# PROBLEM ADVISORY

<b>1. TITLE (Class, Function, Type, etc.)</b>  <b>Linear Mode Application, Power MOSFET</b>		<b>2. DOCUMENT NUMBER</b> <b>FV5-P-09-01A</b>
		<b>3. DATE (DD-MMM-YY)</b> <b>23 APRIL 2009</b>
<b>4. MANUFACTURER AND ADDRESS</b> <b>International Rectifier, HiRel Products</b> <b>205 Crawford Street</b> <b>Leominster, MA 01453</b>	<b>5. PART NUMBER</b> <b>FSC 5961</b>	<b>6. NATIONAL STOCK NUMBER</b> <b>Not Applicable</b>
	<b>7. SPECIFICATION</b> <b>MIL-PRF-19500</b>	<b>8. TYPE DESIGNATOR</b> <b>QPL-19500</b>
	<b>9. LOT DATE CODE START</b> <b>Not Applicable</b>	<b>10. LOT DATE CODE END</b> <b>Not Applicable</b>
<b>11. MANUFACTURER'S POINT OF CONTACT</b> <b>Milt Boden</b>	<b>12. CAGE</b> <b>69210</b>	<b>13. MANUFACTURER'S FAX</b> <b>(978) 537-4246</b>
<b>14. MFR. POC PHONE</b> <b>(310) 726-8029</b>	<b>15. MANUFACTURER'S E-MAIL</b> <b>Mboden1@irf.com</b>	
<b>16. CROSS REFERENCE VENDOR</b> <b>Not Available</b>	<b>17. CROSS REFERENCE CAGE</b> <b>Not Available</b>	<b>18. CROSS REFERENCE PART</b> <b>Not Available</b>

## FV5-P-09-01 – REVISION A

## IRHLNA77064 - SOA CURVE

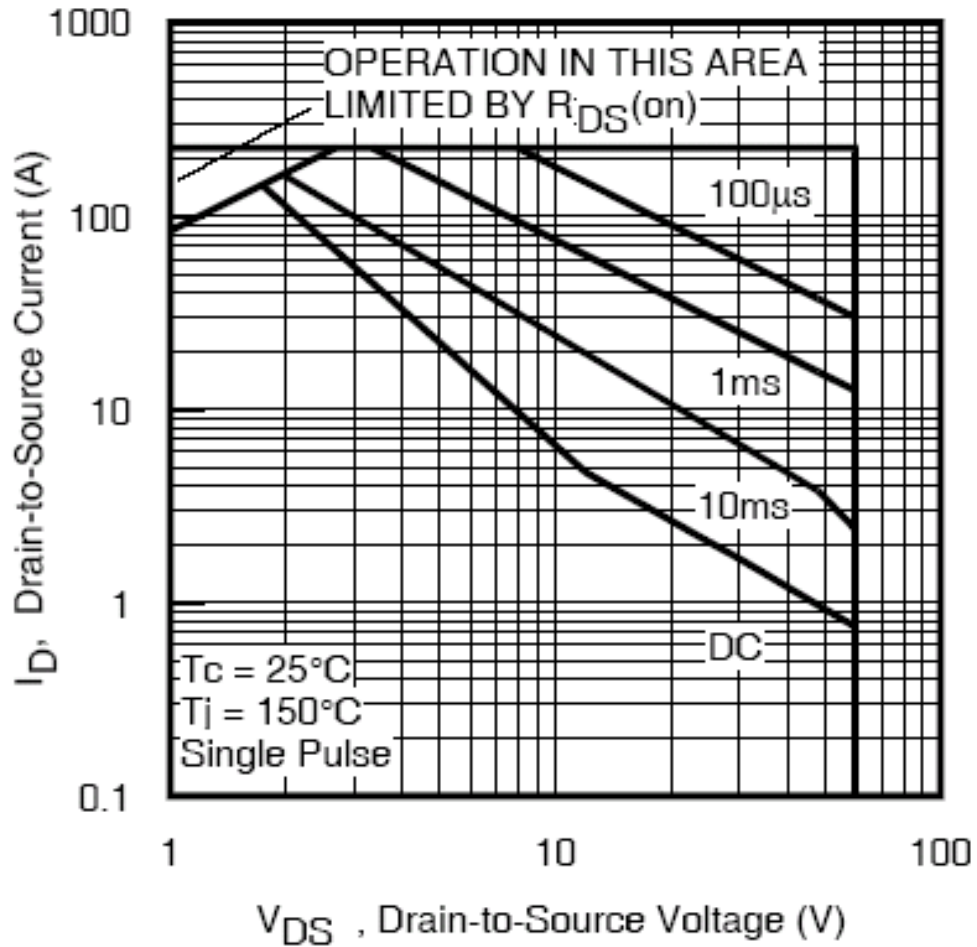
1. The following IR Power MOSFET safe operating area (SOA) curves have been updated with the Direct Current (DC) mode curve.
2. Additional parts SOA curves (with DC characterization) will be updated and maintained in the IR website under the Alerts & Notifications section - <http://www.irf.com/product-info/hi-rel/alerts.html>.
